Project
CONISTON AVENUE, BARTON

Detail
SECTION 185 - PROPOSED DIVERSIONS

Dwn MD Chkd Oct25 Date 1:500Hor 1:100Ver @A1 Scale E24/8080/05/03C Dwg No.

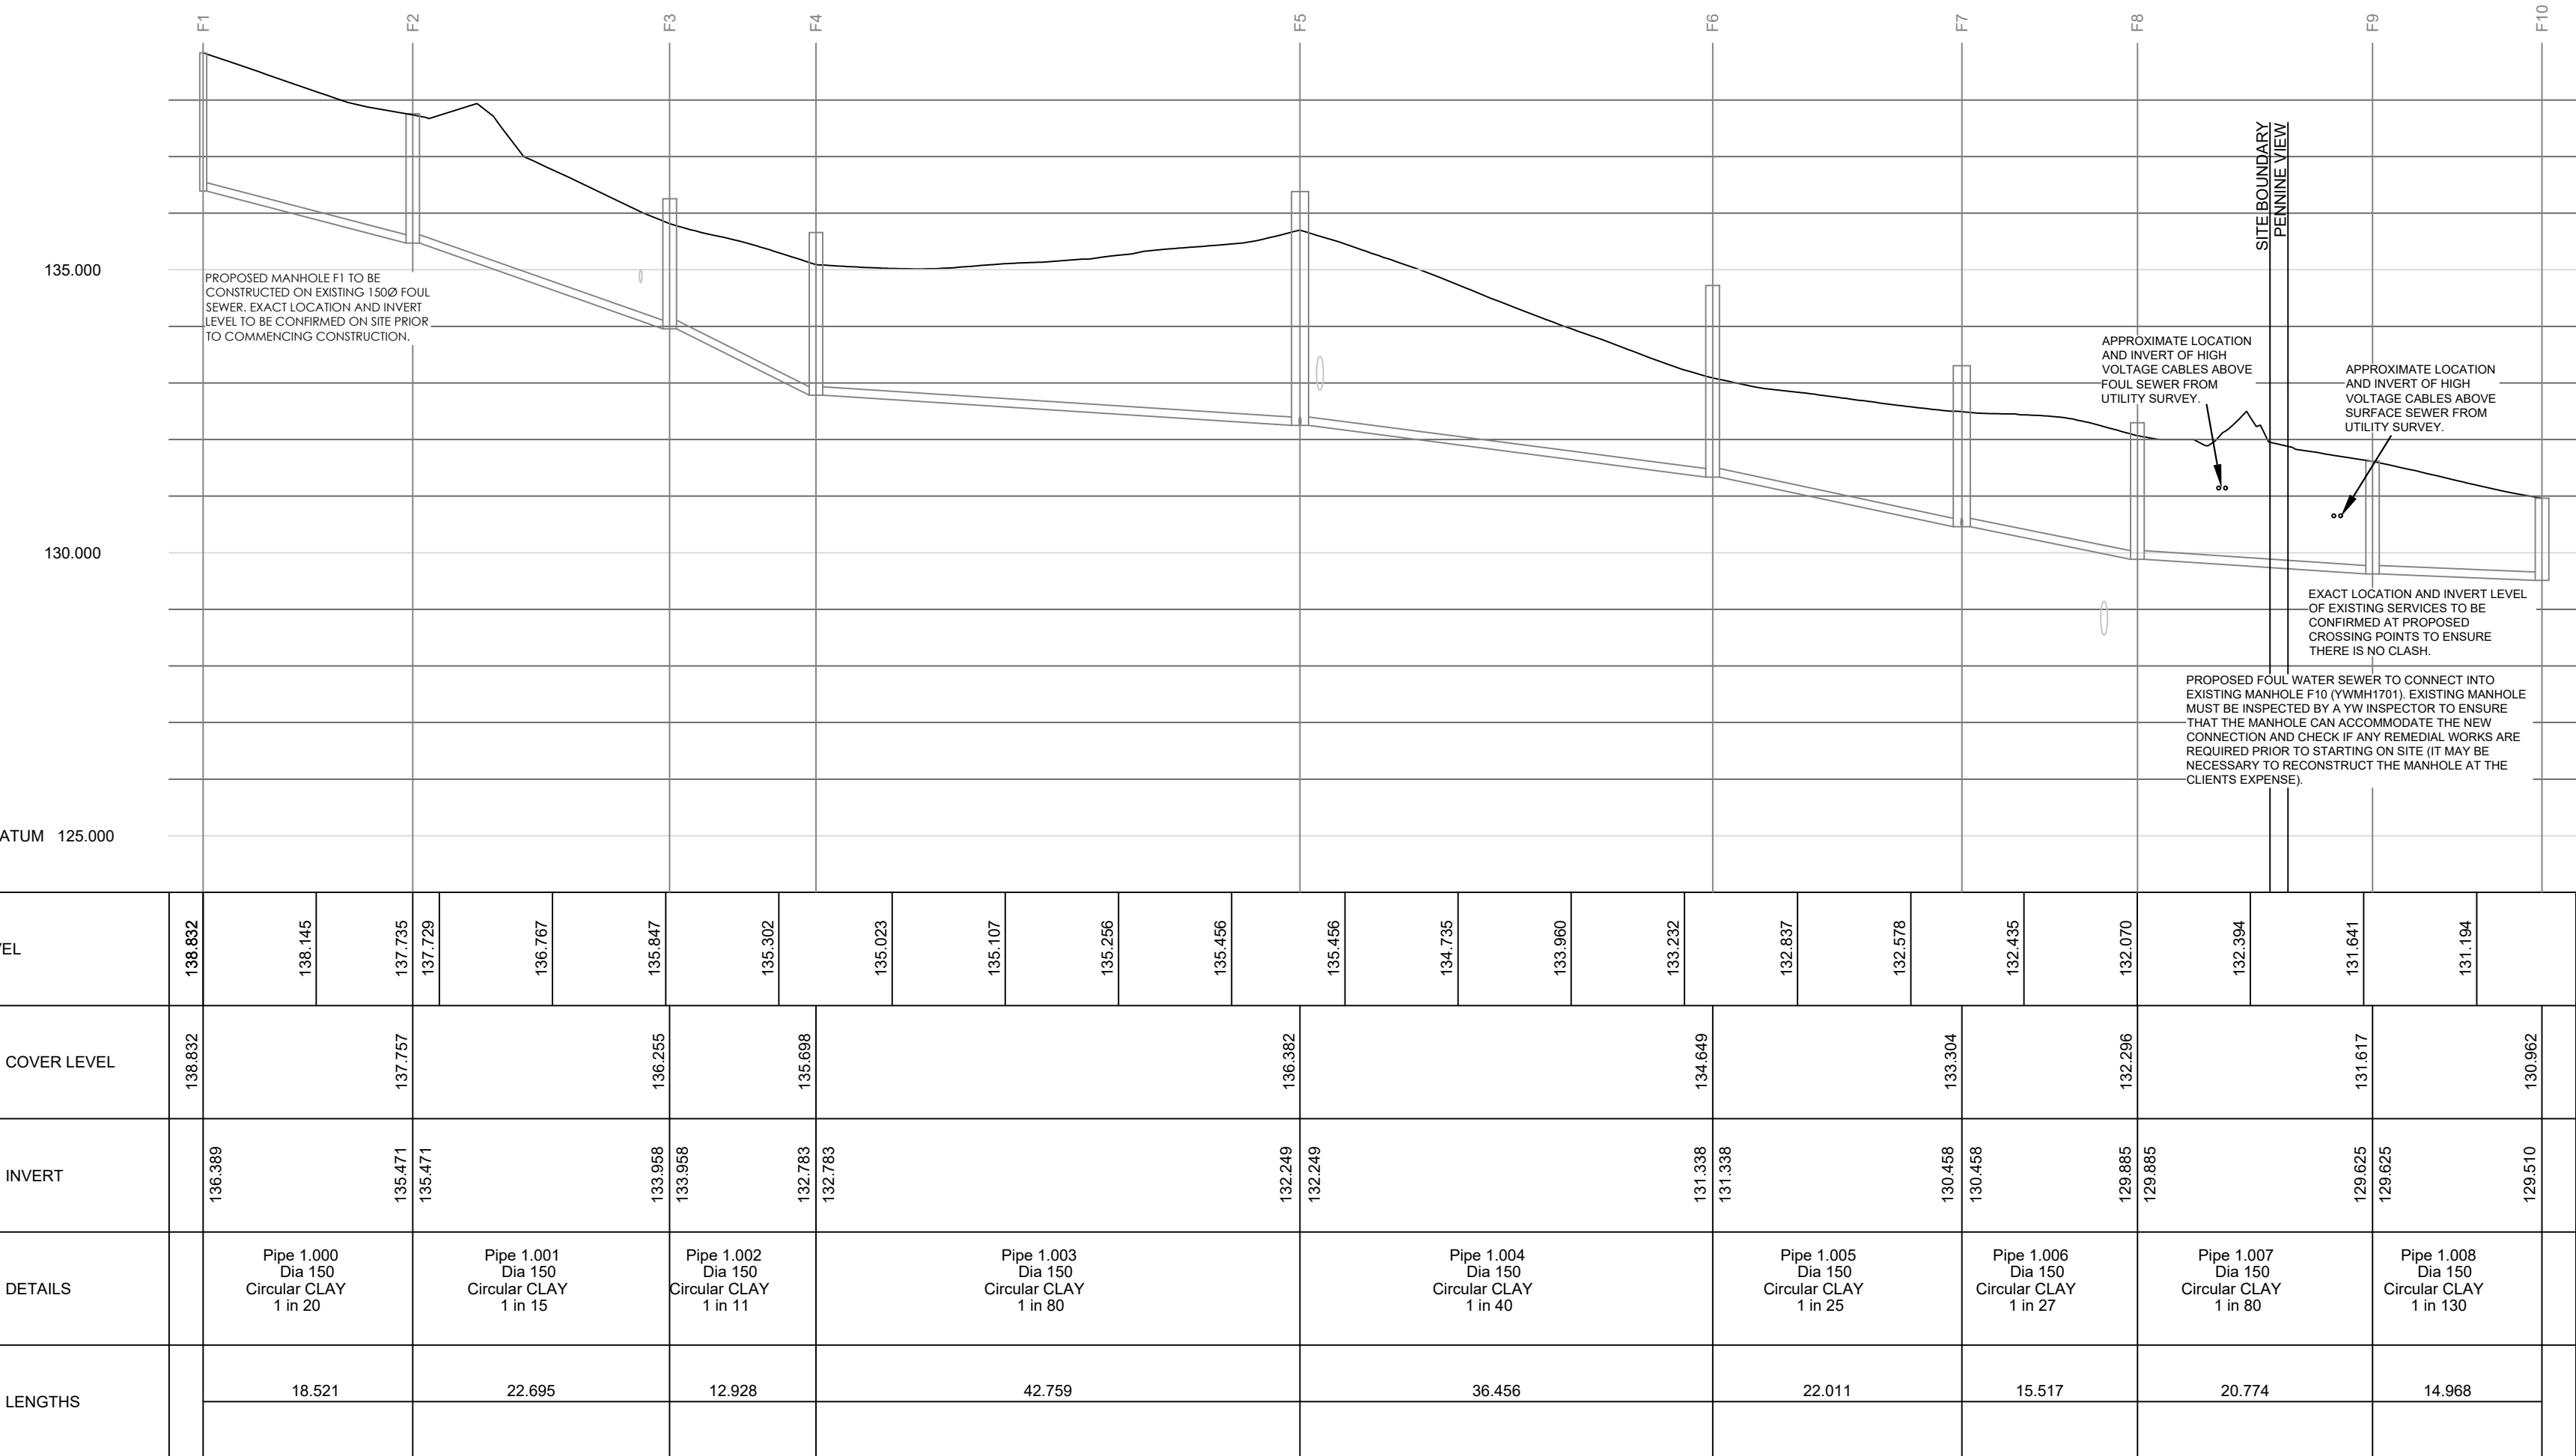
Rev C Proposed 300mm pipework changed to concrete
Rev B Manhole F1 relocated to suit BMBC comments
Rev A Proposed foul sewer section added
